Title:	Proposed Great Wolf Lodge, Chesterton, Bicester	Date Approved:	August 2022
Discipline:	Civils	Author:	Paul Davis
Note Ref:	2180501-EWP-XX-ZZ-TN-C-0006

This technical note has been prepared in response to the Lead Local Flood Authority (LLFA) comments on Condition 16 of application number 22/01815/DISC dated 19.07.22.

Catchment plan and updated below ground drainage drawings

Project no.: 2180501-EWP-Z18-EX-DR-C-1017

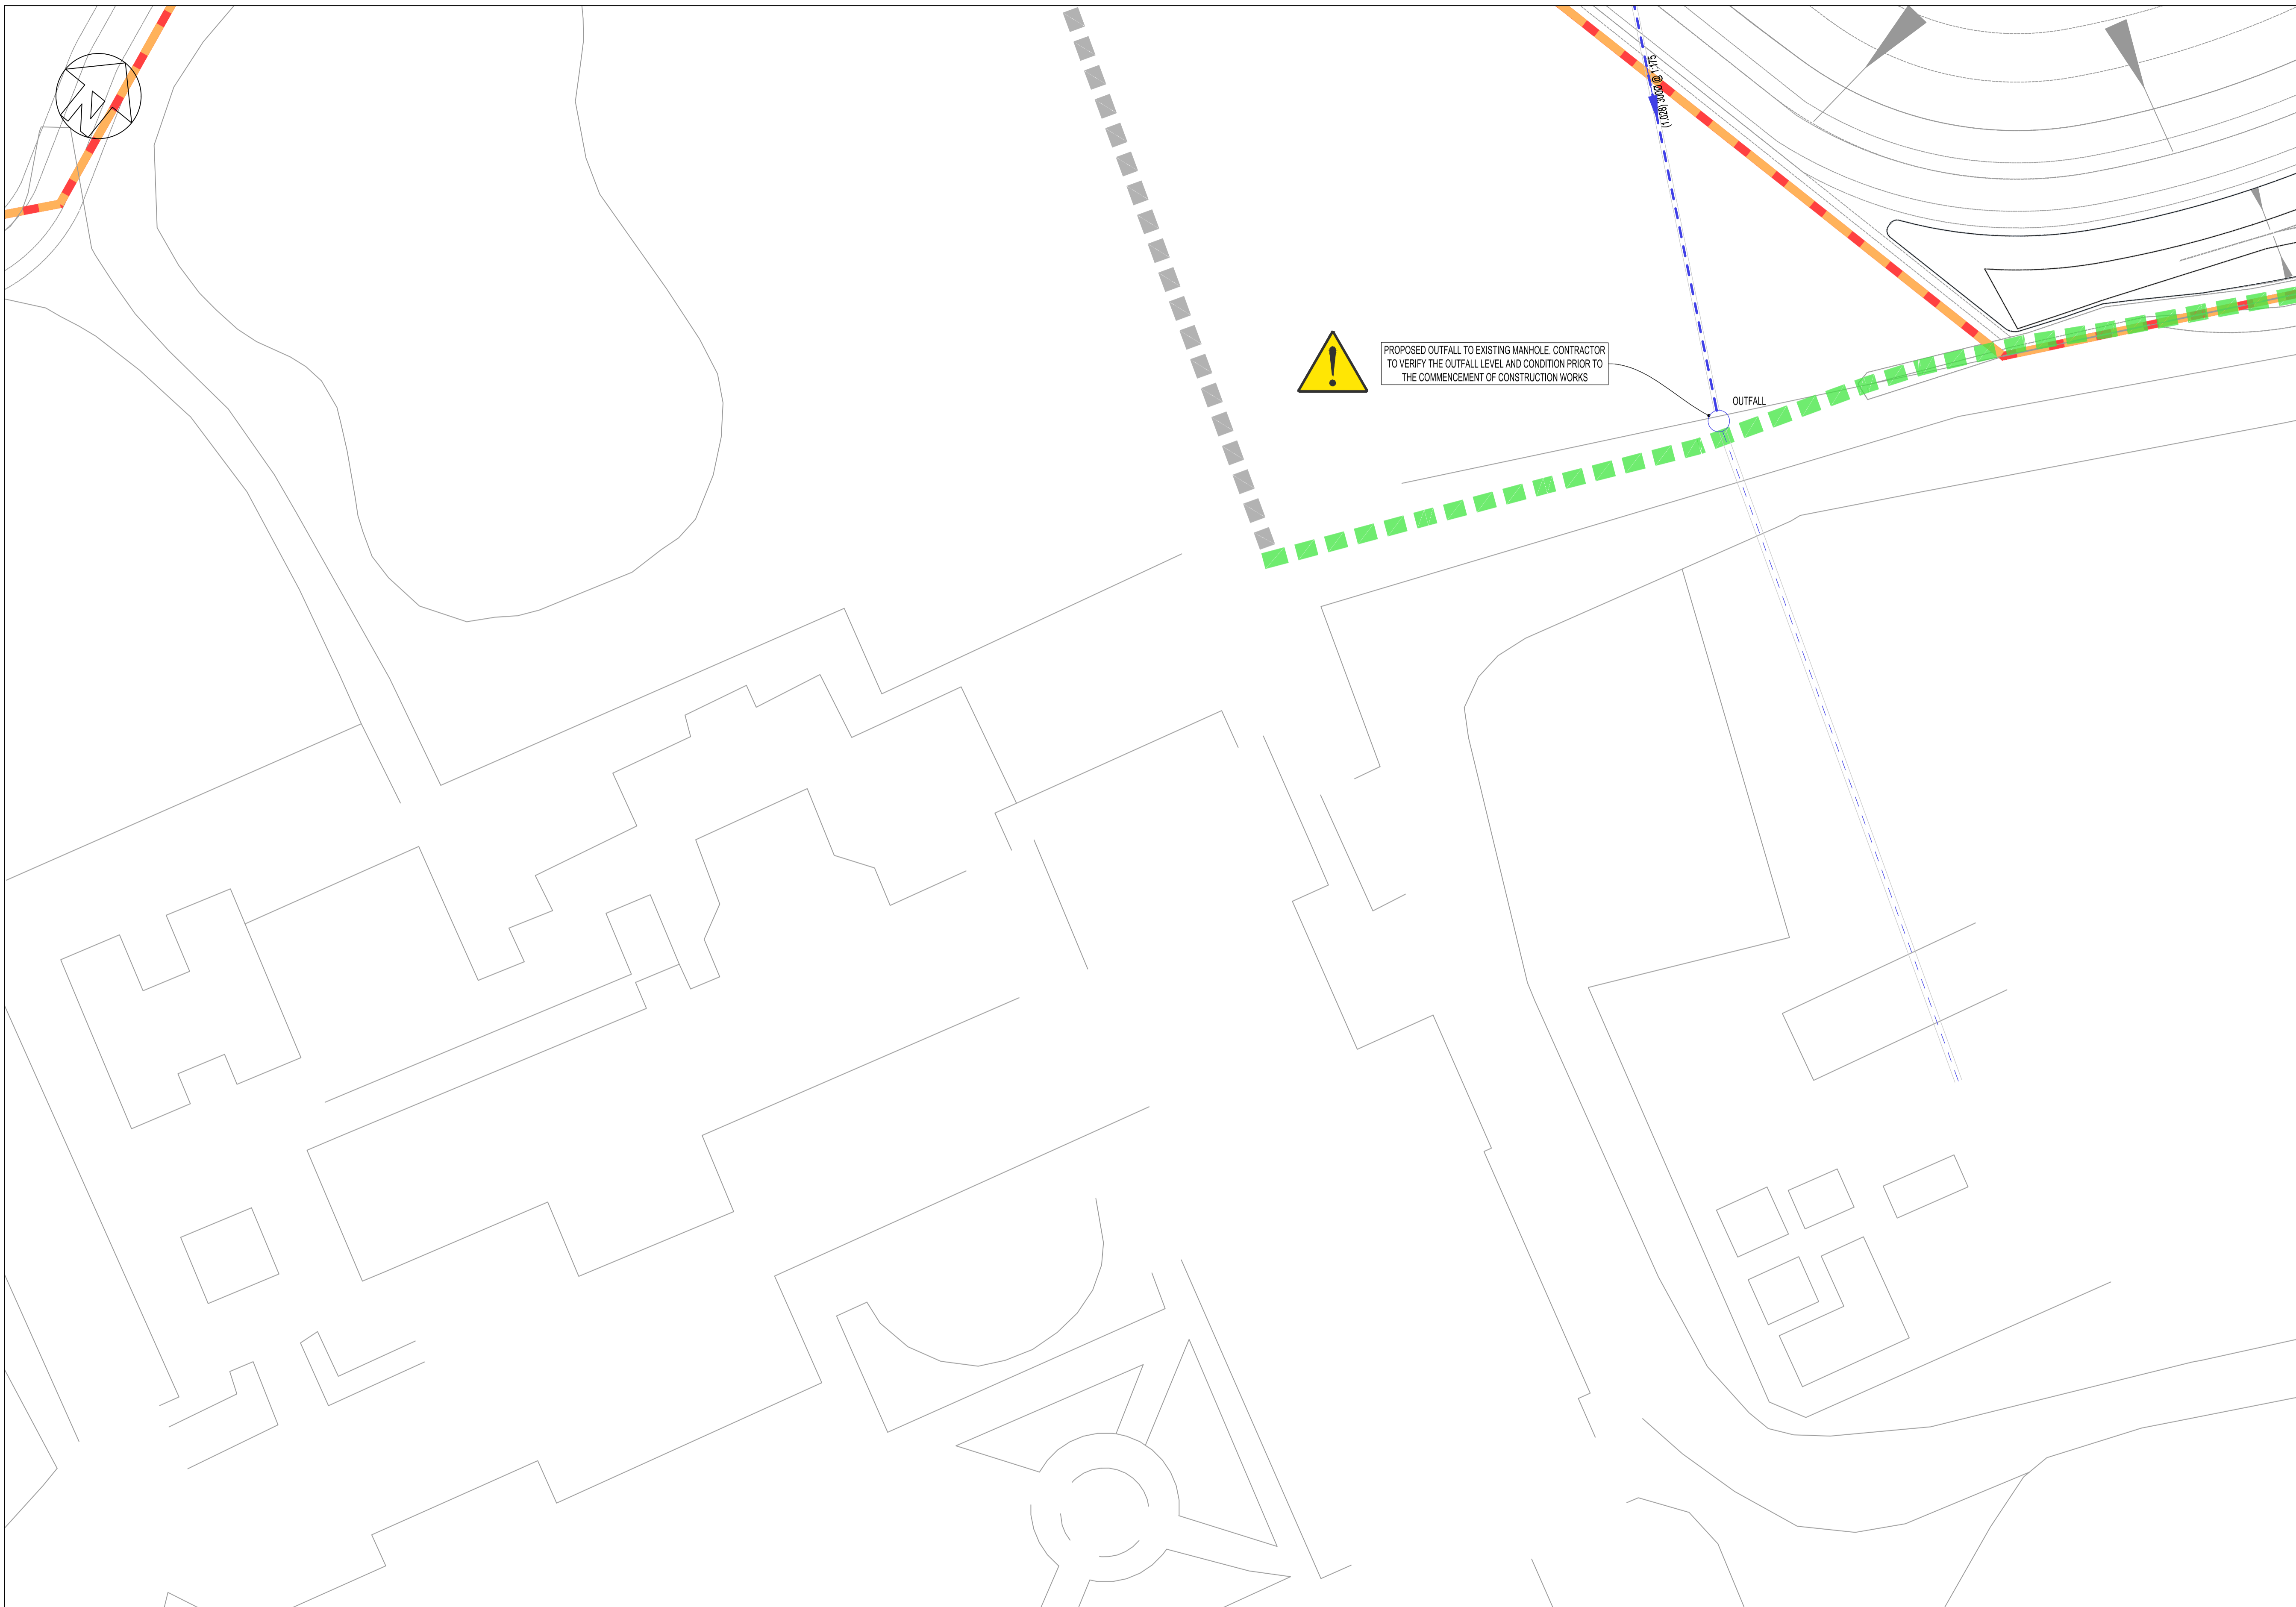
b) Provide surface water catchment plan, clearly showing the extent of the area and stating the area. Ensure all SuDS features are labelled on the drainage strategy drawing and read in line with the calculations.

A catchment plan has been prepared, in addition pipe numbers have been added to the below ground drainage drawings, these drawings are presented in **Appendix A** of this report.
